THE MARYLAND-NATIONAL CAPITAL PARK & PLANNING COMMISSION

**REVISED MEMORANDUM**

**DATE:** ~~October 3,~~ **October 22, 2003**  
**TO:** Montgomery County Planning Board  
**VIA:** Joseph R. Davis, Chief *JRD*  
Michael Ma, Supervisor  
Development Review Division  
**FROM:** Mary Beth O'Quinn *mboq*  
Planning Department Staff  
(301) 495-1322  
**REVIEW TYPE:** Site Plan Review *7,600 SF*  
**APPLYING FOR:** Approval of ~~7,800 sf~~ **7,600 sf** Commercial Retail Space on 0.81 acres  
**PROJECT NAME:** Cloverly Commercial  
**CASE #:** 8-03010  
**REVIEW BASIS:** Site Plan required in the C-1 Zone [§59-C-4.341.2]  
**ZONE:** C-1 Zone  
**LOCATION:** New Hampshire Avenue, 500 feet south of Bryant's Nursery Road  
**MASTER PLAN:** Cloverly  
**APPLICANT:** Darius Vedadi  
**FILING DATE:** October 30, 2002 *NOVEMBER 6, 2003*  
**HEARING DATE:** ~~October 9-~~ **November 6, 2003**

*The revised proposal for Cloverly Commercial. The red lines indicate the locations of the speed humps. The drive aisle has been widened to 24 feet to enhance vehicular safety. The center line will be strined (shown graphically here in blue).*

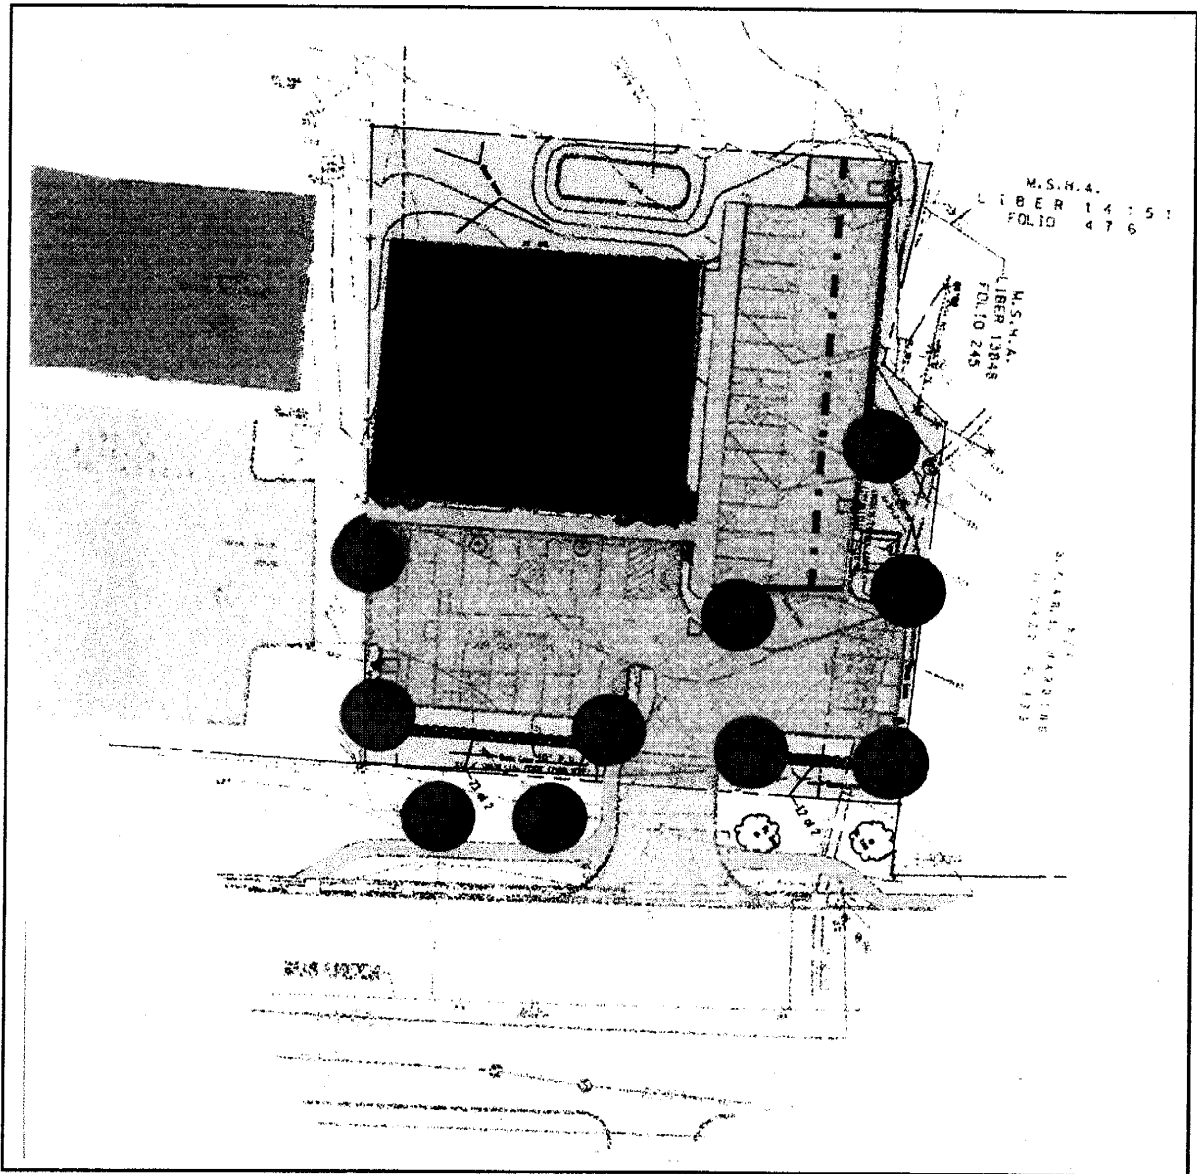
The Community has indicated particular concern about the safety and design adequacy of the proposed internal drive aisle that provides access to the church property at the rear.

**Community Position:** The CAC has indicated that a dedicated, curbed roadway is necessary to provide adequate vehicular access across the commercial property for the anticipated level of use on the church property for religious institutional use or for any use allowed in the RE-2 Zone. Other citizens from the Cloverly Civic Association have called to inquire about the project, and stated that they had no particular comments about the proposal.

**County Position:** The Department of Permitting Services, while considering the original proposal safe and adequate, further recommends three additional design elements to enhance the safety of the drive aisle: a.) widening the drive width to 24 feet; b.) limiting parking to one side or the other along the sides of the drive; and c.) installing one or two speed humps to slow traffic at strategic points. DPS considers the drive aisle, as per the modified design, to be safe and adequate. [See Memorandum from Sarah R. Navid, Department of Permitting Services, dated October 16, 2003, attached.]

**Applicant Position:** In response to the community's concerns, the applicant has modified design elements for the vehicular drive, as recommended by MNCPPC staff and the Department of Permitting Services. The applicant has also voluntarily reduced the square footage of the building to accommodate the driveway design changes. The driveway design modifications meet applicable safety standards.
